CERTIFICATE OF APPROPRIATENESS

Property: 802 Arlington Street, Tracts 13A & 14A, Block 250, Houston Heights Subdivision. The property includes a historic 2,210 square foot 1½-story wood frame single family residence and attached garage situated on an 8,200 square foot (100' x 82') corner lot.

Proposal: Alteration – Revision. This property previously received a COA in November 2014 for a rear addition and a revision in December 2014 for an alteration to a non-original front dormer. In this application, the applicant requests to:

SOUTH SIDE ELEVATION – FACING E. 8TH STREET

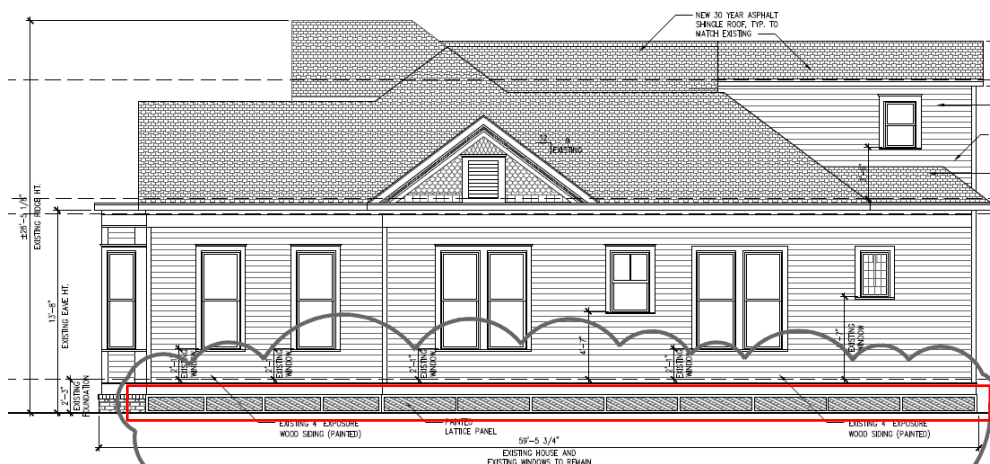
- Replace existing non-original brick skirting on the north and south elevations with wood lattice (the porch and front elevation will retain the brick skirting)
• Replace previously approved rear screen panels with wood siding

The existing brick skirting on the north and south elevations will be replaced with wood lattice panels. However, the brick skirting on the porch and front elevation will be retained. The previously approved rear screen panels will be replaced with wood siding. See drawings for more detail.

EAST (REAR) ELEVATION
EXISTING

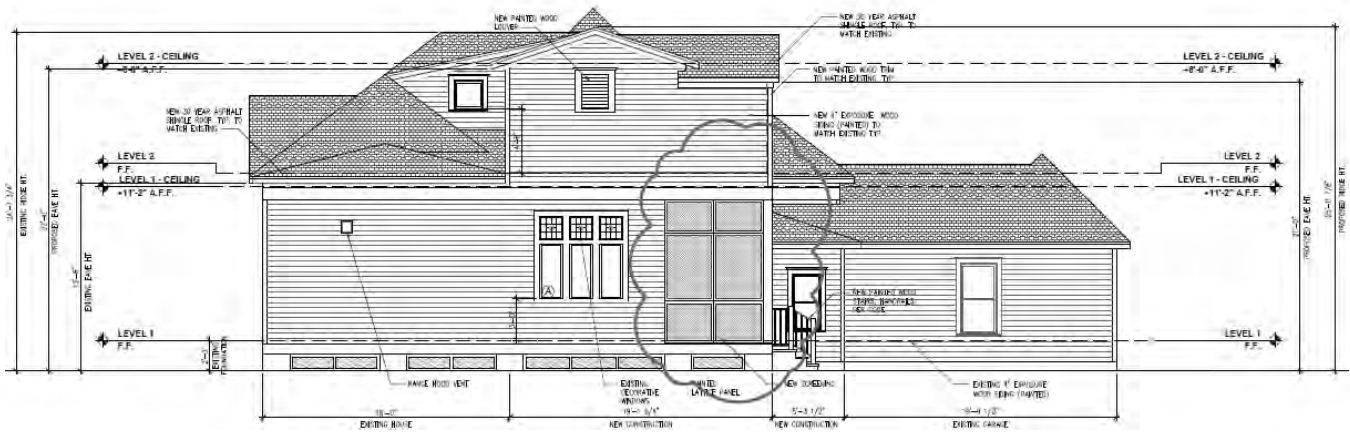
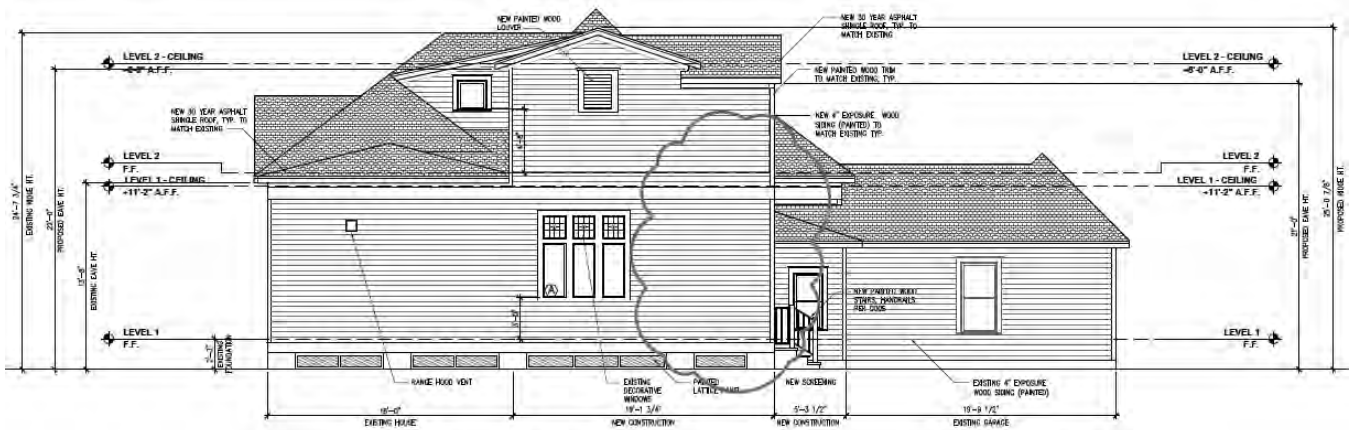
In the revised proposal, the screen panels on the rear elevation will be eliminated and will now be a wall clad with siding. See drawings for more detail.
